## Technical Service Bulletin

93 e-tron GT: required work when replacing the high-voltage battery

Transaction No.: 2077772/1

Release date: May 5, 2025

**Figure 1.** Overview of attachments.

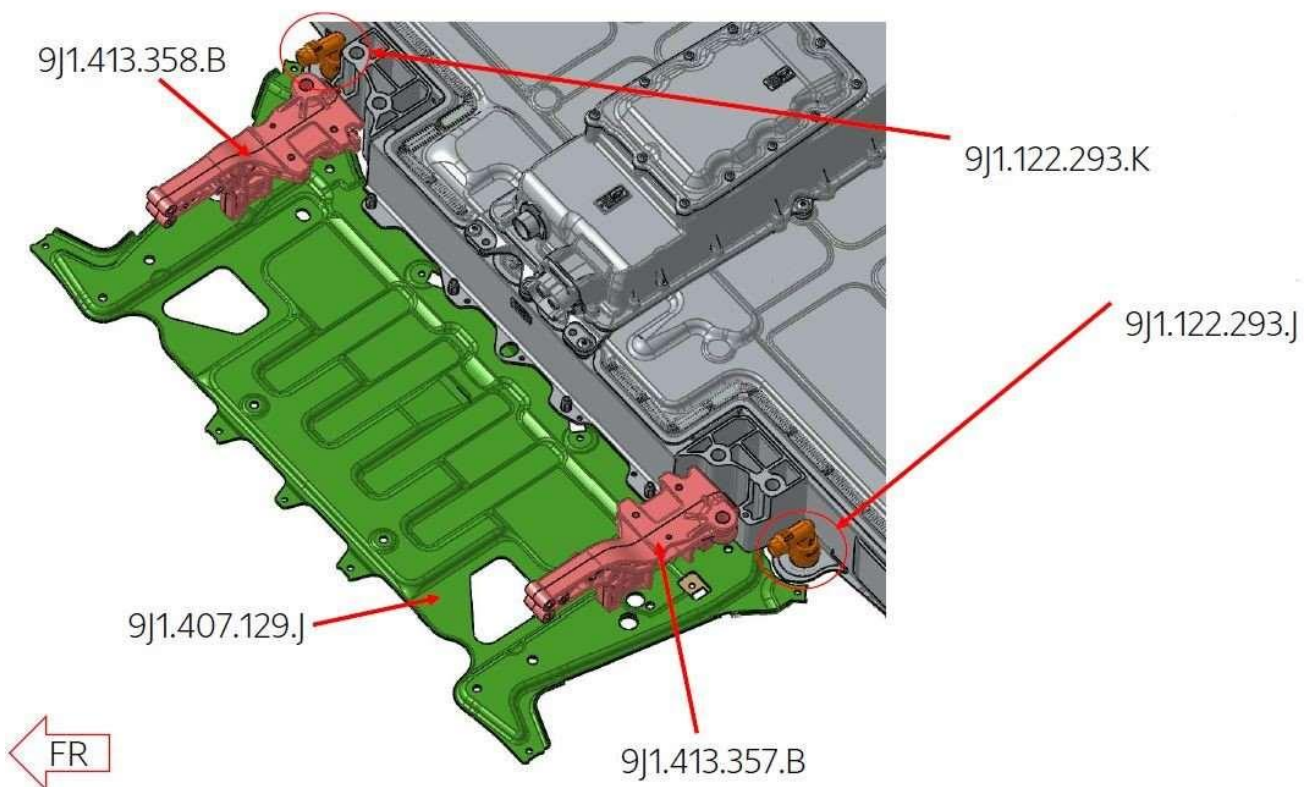
The previous high-voltage battery assembly for the e-tron GT with the part number **9J1.915.100.\*** is no longer available for delivery. As such, if a replacement battery is required, part number **9J1.915.590.\*** must be used. A small number of attachments must be replaced (Figure 1) and several steps listed under Measure must be observed.

Begin by entering the VIN number in the electronic parts catalogue and order the correct high-voltage battery for the vehicle and the following additional parts for the replacement:

Part number	Designation	Quantity
9J1.122.293.K	Coolant connection (right side)	1
9J1.122.293.J	Coolant connection (left side)	1
9J1.413.357.B	Link for stabilizer (left side) (side panel)	1
9J1.413.358.B	Link for stabilizer (right side)	1
9J1.407.129.J	Reinforcement plate	1
N.108.317.01	Screw with int. serrations for front stabilizer link	2
N.104.355.06	Self-locking hexagon collar nut for stabilizer link bolts	2
N.107.822.01	Hexagon bolt for side panel ONLY RIGHT SIDE	1
N.104.355.06	Self-locking hexagon collar nut for side panel ONLY RIGHT SIDE	1
N.912.443.01	Hexagon collared bolt with hexagon socket head (duo), bolt with washer for bottom of side panel	2
N.910.062.02	Hexagon bolt head (combi) for stabilizer clamp	4
N.106.645.03	Hex collared bolt Z for mounting bracket on front axle	4
971.411.313.K	Rubber bush	4
9J1.010.003.B	Notice (E test mark)	1

**Figure 2.** Label position location.

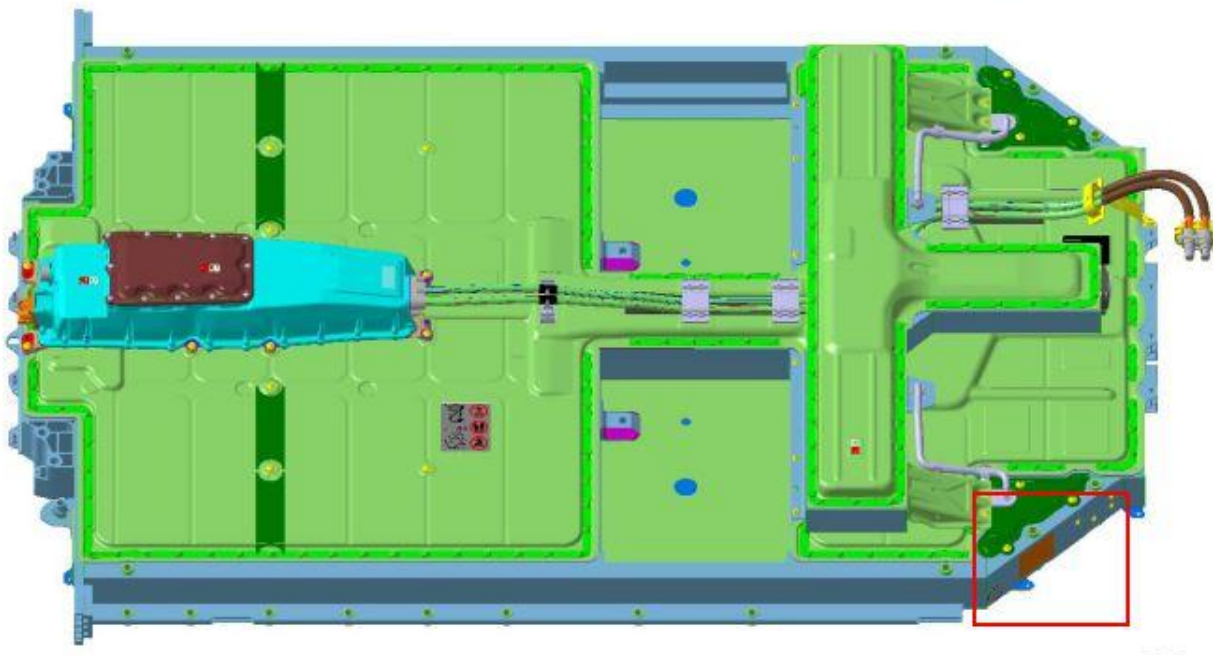
- Fit attachments for front coolant connection (b): **9J1.122.293.J** and **9J1.122.293.K**
- Affix notice **9J1.01.003.B** (E test mark) next to high-voltage battery type plate (Figure 2).

**Figure 3.** Stabilizer link.

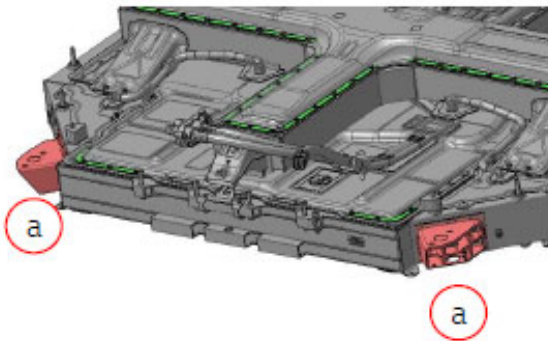
- Replace stabilizer links (both sides) to the geometry of the e-tron GT PU
  - | >> Running gear, axles, steering; Rep. gr. 40; Subframe; Removing and installing subframe bracket
- Replace stabilizer link (left side) **9J1.413.357.A** with **9J1.413.357.B**
- Replace stabilizer link (right side) **9J1.413.358.A** with **9J1.413.358.B**
- Replace bolts (stretch bolts) and check rubber bushes for wear; replace if necessary
